Access Compliance Report

Public Rights-of-Way

(Curb Ramps)

Intersection ID: 31748	Main Street: GRAPETREE_CT	Cross Street: WASHOE_PINE_LN	Location: SE
ADA ID: B36924650FDE	Ramp Type: PerpDiag	Initial Pass/Fail: Fail	Overall Compliance: No
Severity Score: 21.25			
Codes/Mitigation Info/Possible Solution		Field Measurements/Component Compliance

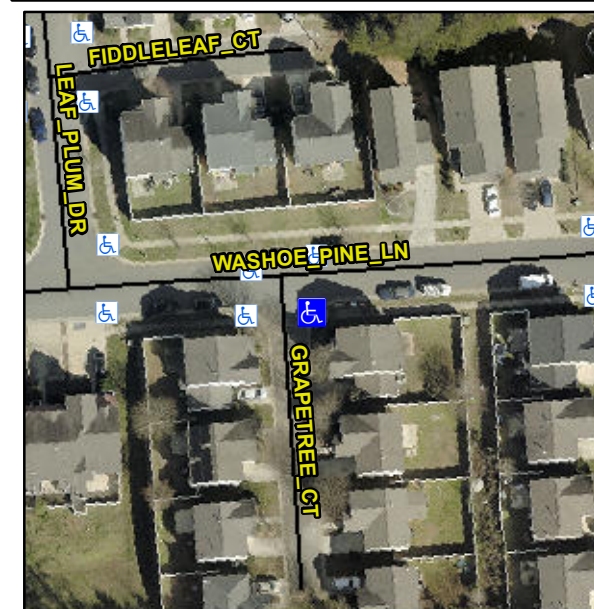
Not Found, R304.5.1, R304.5.3

Compliance	Description	Data	Compliance	Description	Data
N/A	Ramp Length (in)	47.0	Yes	Ramp Slope (%)	6.7
No	Ramp Width (in)	47.5	No	Ramp XSlope (%)	6.1
N/A	Flare Type LT	N/A	N/A	Flare Type RT	N/A
N/A	Flare Slope LT (%)	N/A	N/A	Flare Slope RT (%)	N/A
N/A	Flare Traversable LT?	N/A	N/A	Flare Traversable RT?	N/A
N/A	Landing Length (in)	N/A	N/A	DWS Provided?	N/A
N/A	Landing Width (in)	N/A	N/A	DWS Contrast?	N/A
N/A	Landing Slope (%)	N/A	N/A	DWS Length (in)	N/A
N/A	Landing X Slope (%)	N/A	N/A	DWS Full Width?	N/A
N/A	Landing Curb? (Y/N)	N/A	N/A	DWS Offset (in)	N/A
N/A	Shared Landing?	N/A			
N/A	Gutter Ponding?	N/A	N/A	Gutter Slope (%)	N/A
N/A	Gutter Lip Ht (in)	N/A	N/A	Gutter X Slope (%)	N/A
N/A	Painted X Walk1?	No	N/A	Painted X Walk2?	No
	X Walk 1 Direction	To N		X Walk 2 Direction	To W
N/A	X Walk 1 Width (in)	N/A	N/A	X Walk 2 Width (in)	N/A
	X Walk 1 Slope (%)	1.3		X Walk 2 Slope (%)	4.7
	X Walk 1 X Slope (%)	6.8		X Walk 2 X Slope (%)	0.3

Remove & Replace Curb Ramp With Two New Directional Ramps or Equivalent.
